QUALITY ASSURANCE -- NON-CONFORMANCE REPORT

Location: Changxing Island, Shanghai, PRC **Report No:** NCR-000356
Prime Contractor: American Bridge/Fluor Enterprises, a JV **Date:** 12-Jul-2009
Submitting Contractor: Zhenhua Port Machinery Company, Ltd (ZPMC), Changxing Island **NCR #:** ZPMC-0330

Reference Description: CA Open Rib Stiffeners on OBG Segment 8AE

Job Name: SAS Superstructure

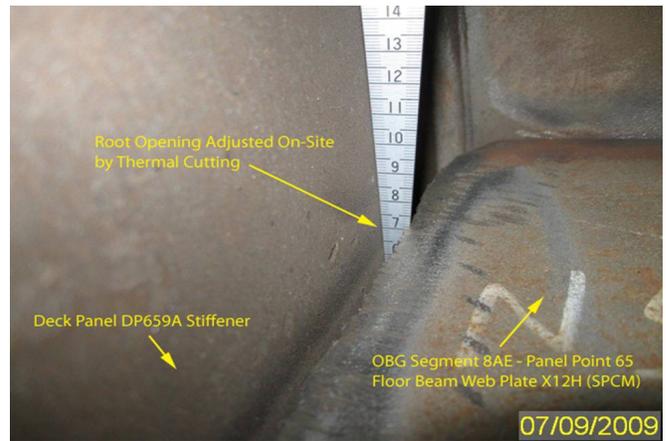
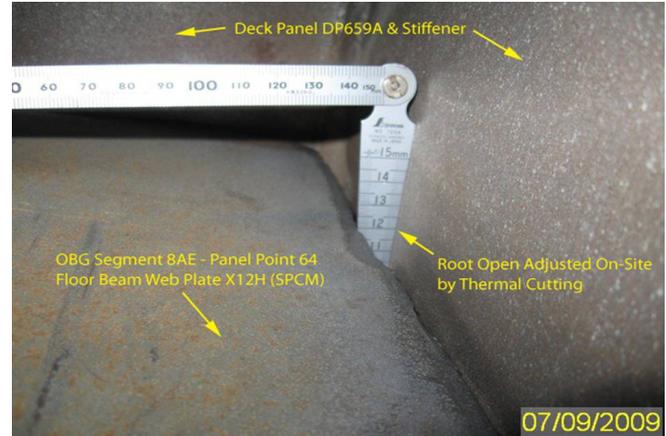
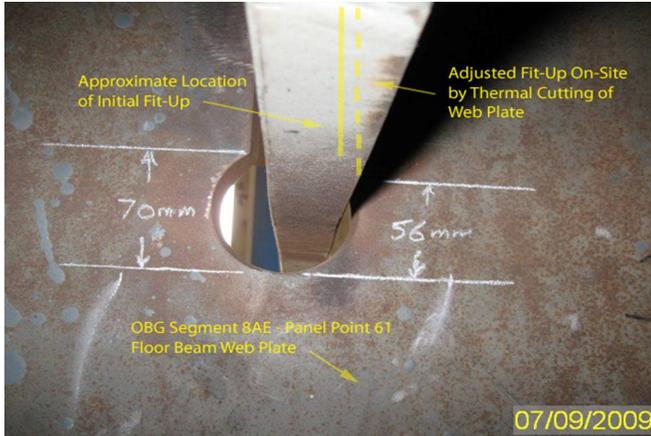
Caltrans Quality Assurance (QA) Inspector observed Thermal Cutting of Floor Beam Web Plates to allow fit-up of Panel Stiffeners in OBG Segment designated as 8AE on the Crossbeam side between Panel Points 61 and 64. This process created excessive root openings which will apparently prohibit ZPMC from completing the welding process with the specified fillet welds.

3.3.1: “The parts to be joined by fillet welds shall be brought into as close contact as practicable. The root opening shall not exceed 5mm (3/16”).”

Gaps greater than 5mm require build up by buttering the plate edge to an acceptable gap or changing the joint configuration to a CJP to a pre-approved procedure. Prior to performing CJP welding ZPMC/ABF is required to notify the engineer. ZPMC will submit repair reports at a later date to close this NCR.

Please provide documentation of the steps taken to minimize the excessive root gap, and provide inspection documentation that the weld is acceptable. The Department will review the Contractor's proposal to close Non-Conformance ZPMC-0330 at that time.

WELD NUMBER: SSD18-PP064-140

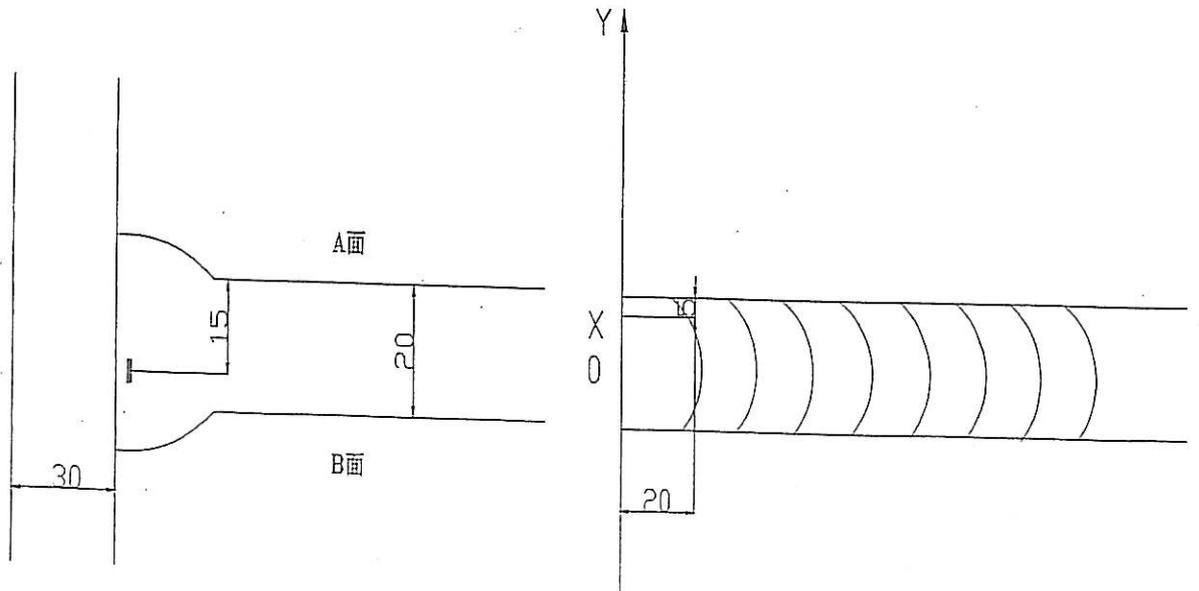
Rejected indication found by ultrasonic inspection is less than the maximum allowance aggregate length.

1. 焊道未及时处理干净。
1. Did not clear the weld pass completely in time.

1. 从缺陷距离端面较近一侧 ($D \leq 0.65T$, D 为缺陷深度, T 为板厚) 采用碳刨或打磨的方法去除焊缝缺陷;
 2. 参照返修焊接工艺规程 (WPS) 准备正确的接头型式, 预热和焊接;
 3. 焊前对修补区域进行VT检测保证缺陷完全被清除;
 4. 将修补区域打磨到与母材或邻近焊缝平齐;
 5. 根据批准的车间图纸检查焊缝.
-
1. Gouge or grind from nearer side from metal edge ($D \leq 0.65T$, "D" is depth of defects, "T" is thickness of metal) to remove all defects;
 2. Follow repair WPS for joint preparation, preheat, and weld deposit;
 3. Verify with VT no defects remain in the weld joint prior to welding;
 4. Grind the repaired area flush with base metal or the adjacent weld;
 5. Check the welds according to the working drawings.

WELD NUMBER: SSD18-PP064-146

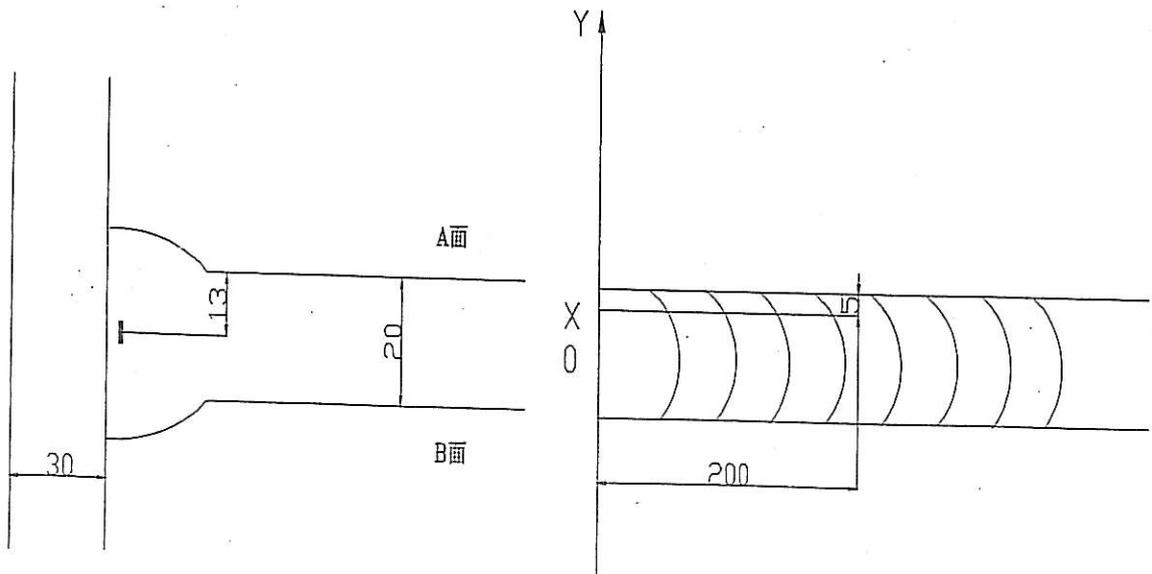
Rejected indication found by ultrasonic inspection is less than the maximum allowance aggregate length.

1. 焊道未及时处理干净。
1. Did not clear the weld pass completely in time.

1. 从缺陷距离端面较近一侧 ($D \leq 0.65T$, D为缺陷深度, T为板厚) 采用碳刨或打磨的方法去除焊缝缺陷;
 2. 参照返修焊接工艺规程 (WPS) 准备正确的接头型式, 预热和焊接;
 3. 焊前对修补区域进行VT检测保证缺陷完全被消除;
 4. 将修补区域打磨到与母材或邻近焊缝平齐;
 5. 根据批准的车间图纸检查焊缝.
1. Gouge or grind from nearer side from metal edge ($D \leq 0.65T$, "D" is depth of defects, "T" is thickness of metal) to remove all defects;
 2. Follow repair WPS for joint preparation, preheat, and weld deposit;
 3. Verify with VT no defects remain in the weld joint prior to welding;
 4. Grind the repaired area flush with base metal or the adjacent weld;
 5. Check the welds according to the working drawings.

WELD NUMBER: SSD18-PP064-150

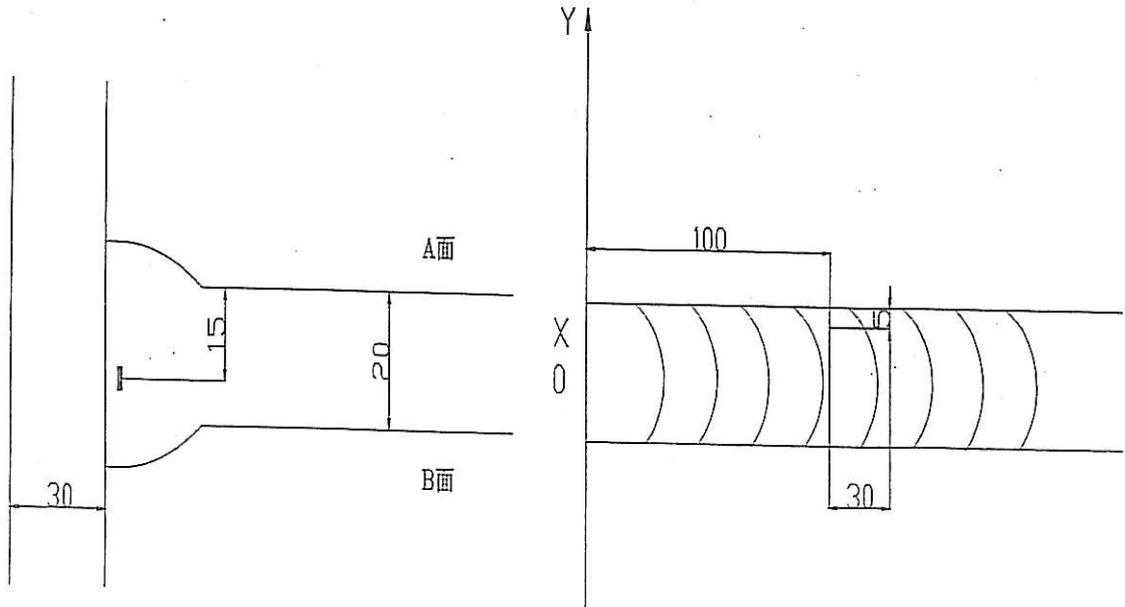
Rejected indication found by ultrasonic inspection is less than the maximum allowance aggregate length.

1. Did not clear the weld pass completely in time.

1. Gouge or grind from nearer side from metal edge ($D \leq 0.65T$, "D" is depth of defects, "T" is thickness of metal) to remove all defects;
2. Follow repair WPS for joint preparation, preheat, and weld deposit;
3. Verify with VT no defects remain in the weld joint prior to welding;
4. Grind the repaired area flush with base metal or the adjacent weld;
5. Check the welds according to the working drawings.

WELD NUMBER: SSD17-PP063-137

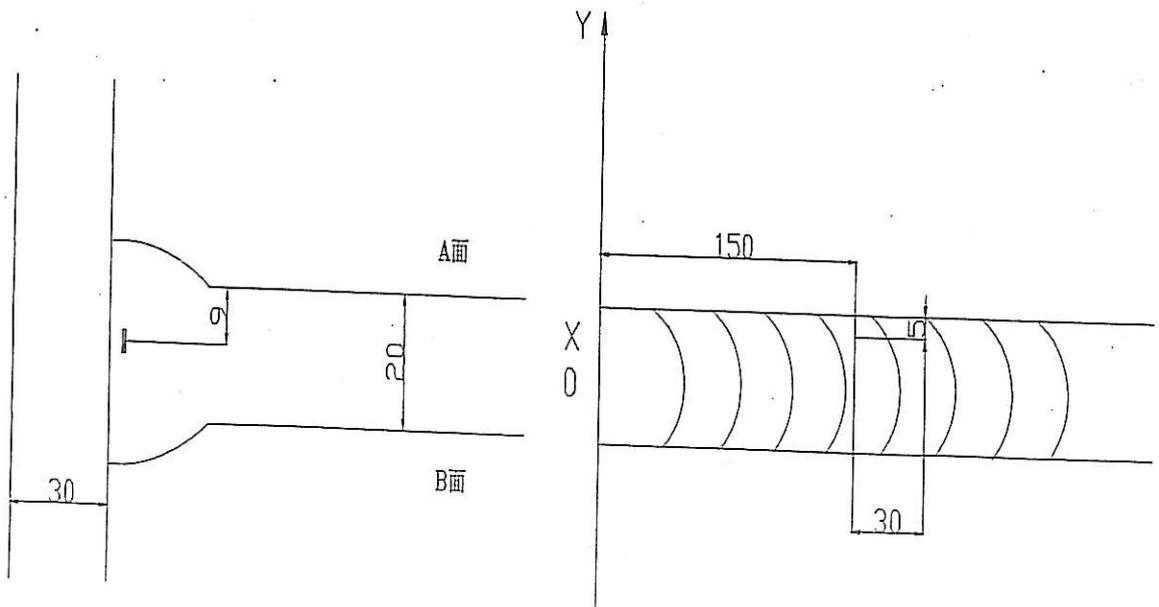
Rejected indication found by ultrasonic inspection is less than the maximum allowance aggregate length.

1. Did not clear the weld pass completely in time.

1. Gouge or grind from nearer side from metal edge ($D \leq 0.65T$, "D" is depth of defects, "T" is thickness of metal) to remove all defects;

2. Follow repair WPS for joint preparation, preheat, and weld deposit;

3. Verify with VT no defects remain in the weld joint prior to welding;

4. Grind the repaired area flush with base metal or the adjacent weld;

5. Check the welds according to the working drawings.

WELD NUMBER: SSD24-PP061.5-135

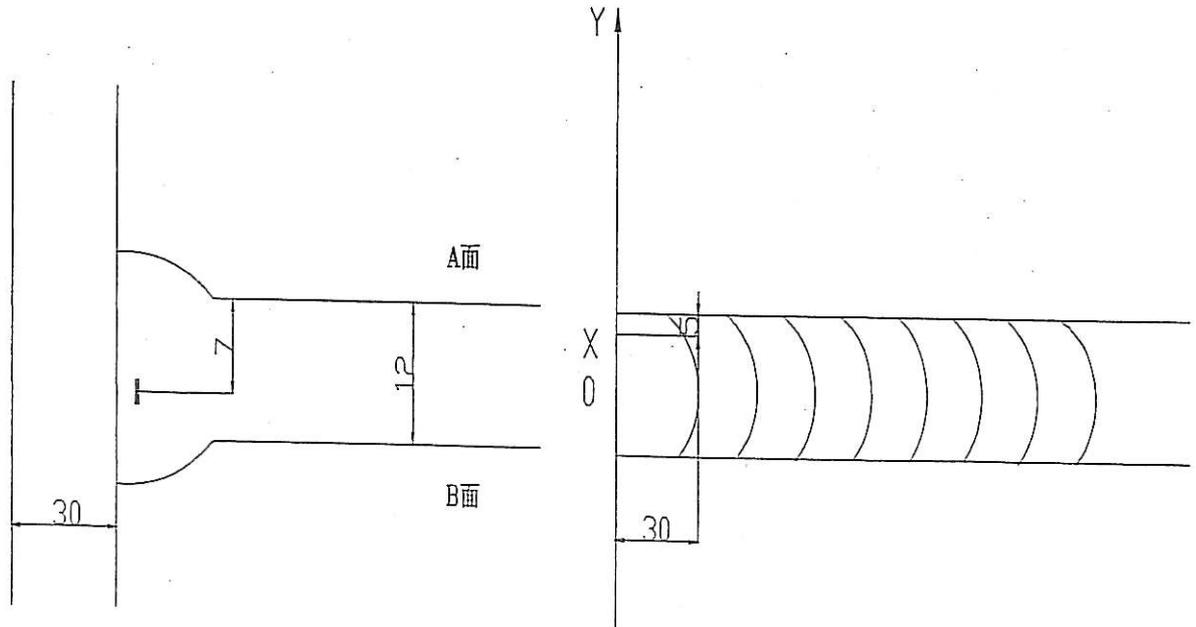
Rejected indication found by ultrasonic inspection is less than the maximum allowance aggregate length.

- 1、焊道未及时处理干净。
1. Did not clear the weld pass completely in time.

1. 从缺陷距离端面较近一侧 ($D \leq 0.65T$, D 为缺陷深度, T 为板厚) 采用碳刨或打磨的方法去除焊缝缺陷;
 2. 参照返修焊接工艺规程 (WPS) 准备正确的接头型式, 预热和焊接;
 3. 焊前对修补区域进行VT检测保证缺陷完全被清除;
 4. 将修补区域打磨到与母材或邻近焊缝平齐;
 5. 根据批准的车间图纸检查焊缝.
-
1. Gouge or grind from nearer side from metal edge ($D \leq 0.65T$, "D" is depth of defects, "T" is thickness of metal) to remove all defects;
 2. Follow repair WPS for joint preparation, preheat, and weld deposit;
 3. Verify with VT no defects remain in the weld joint prior to welding;
 4. Grind the repaired area flush with base metal or the adjacent weld;
 5. Check the welds according to the working drawings.

WELD NUMBER: SSD15-PP061-143

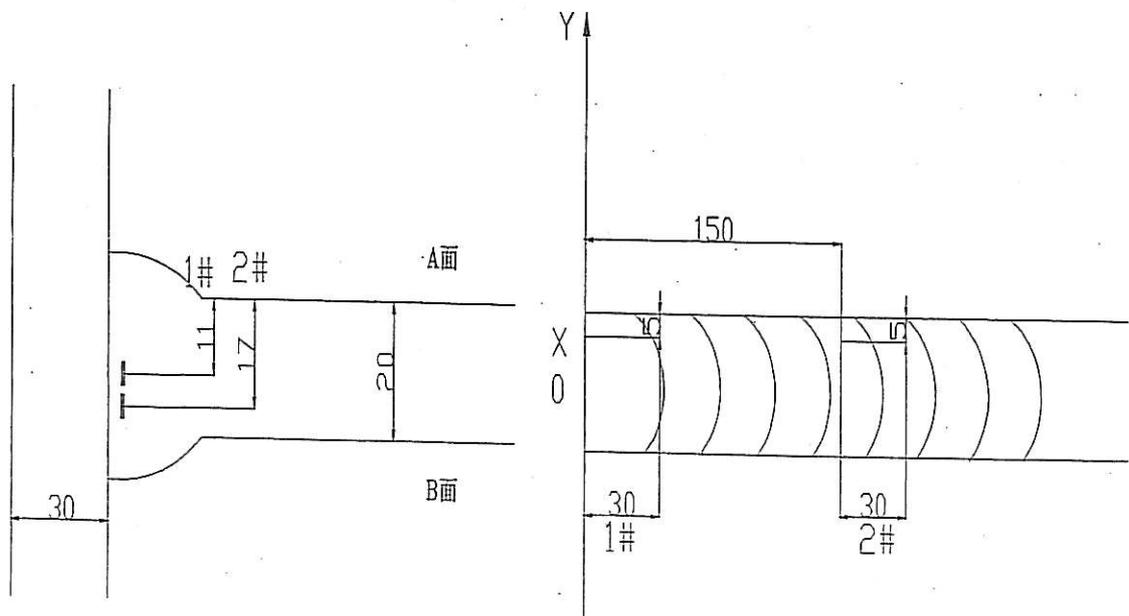
Rejected indication found by ultrasonic inspection is less than the maximum allowance aggregate length.

1. Did not clear the weld pass completely in time.

1. Gouge or grind from nearer side from metal edge ($D \leq 0.65T$, "D" is depth of defects, "T" is thickness of metal) to remove all defects;

2. Follow repair WPS for joint preparation, preheat, and weld deposit;

3. Verify with VT no defects remain in the weld joint prior to welding;

4. Grind the repaired area flush with base metal or the adjacent weld;

5. Check the welds according to the working drawings.

WELD NUMBER: SSD15-PP061-135

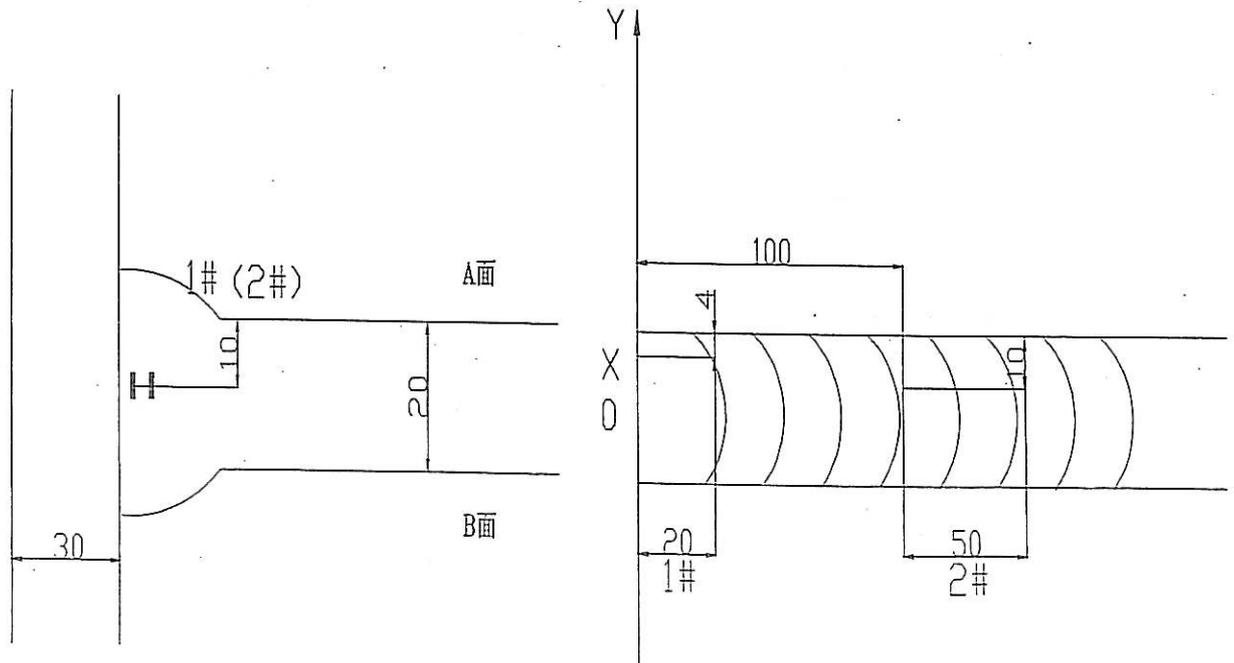
Rejected indication found by ultrasonic inspection is less than the maximum allowance aggregate length.

1. Did not clear the weld pass completely in time.

1. Gouge or grind from nearer side from metal edge ($D \leq 0.65T$, "D" is depth of defects, "T" is thickness of metal) to remove all defects;

2. Follow repair WPS for joint preparation, preheat, and weld deposit;

3. Verify with VT no defects remain in the weld joint prior to welding;

4. Grind the repaired area flush with base metal or the adjacent weld;

5. Check the welds according to the working drawings.
